**KNOXVILLE/KNOX COUNTY METROPOLITAN PLANNING COMMISSION
 USE ON REVIEW REPORT**

▶ **FILE #:** 8-E-15-UR **AGENDA ITEM #:** 40
 POSTPONEMENT(S): 8/13/2015 **AGENDA DATE:** 9/10/2015
 ▶ **APPLICANT:** BECKY MASSEY SERTOMA CENTER
 OWNER(S): Olivia Parfait

▶ **PROPOSED USE:** Duplex

**SITE PLAN**
 1
 SD-1
 SCALE: 1" = 20'-0"

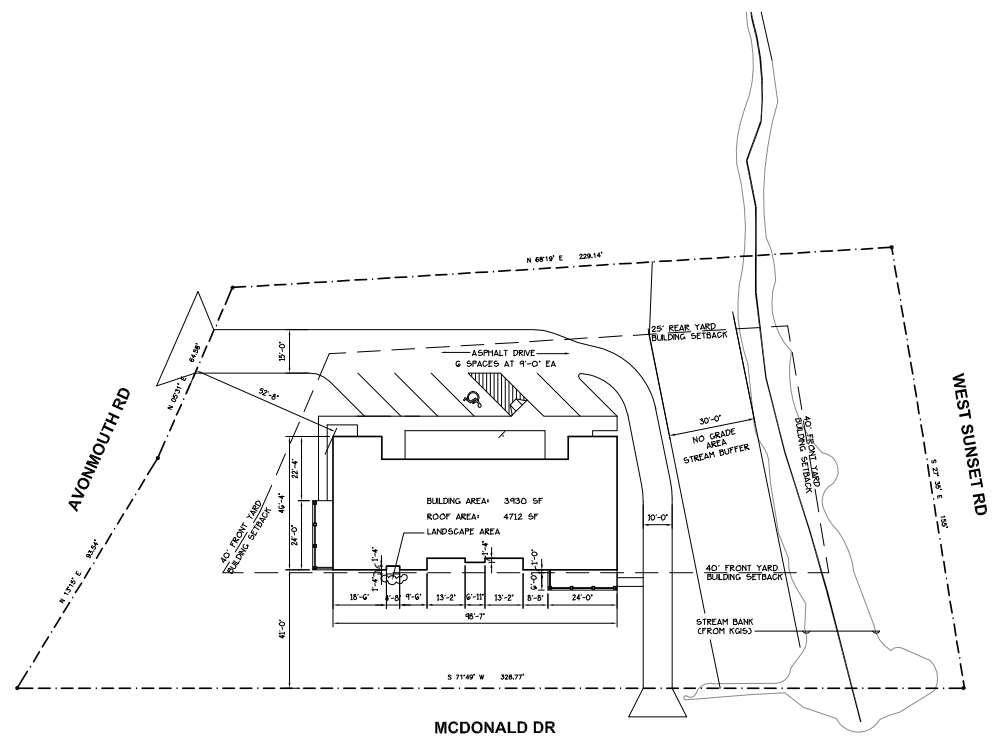
1. The grade of the driveway from Avonmouth Rd. shall be in conformance with the requirements of the City of Knoxville Fire Department. If the Avonmouth Rd. driveway is eliminated, the driveway from McDonald Dr. shall only be widened the minimum amount recommended by the City of Knoxville Department of Engineering or Plans Review and Inspections.

2. The parking area shall be screened from the adjoining property (to the rear) with a type "C" partial landscaping screen (see copy attached).
3. A 30-foot buffer, as measured from the top of the stream bank, shall be left undisturbed, unless otherwise approved by the City of Knoxville Department of Engineering.
4. The finished floor elevation (FFE) of the duplex must be a minimum of 1-foot above the lowest elevation of McDonald Drive, or otherwise approved by the City of Knoxville Department of Engineering.

Duplexes are a use permitted on review in the EN-1 zone district, provided the duplex is located on a lot with two street frontages and each primary entrance faces a different street. In addition, duplexes have to meet the same design requirements as detached houses. The proposed duplex design and site improvements are consistent with the requirements of the EN-1 zone. However, because of the size of the parking area and the potential to adversely impact the adjoining property, a condition has been recommended that the parking area be screened with landscaping.
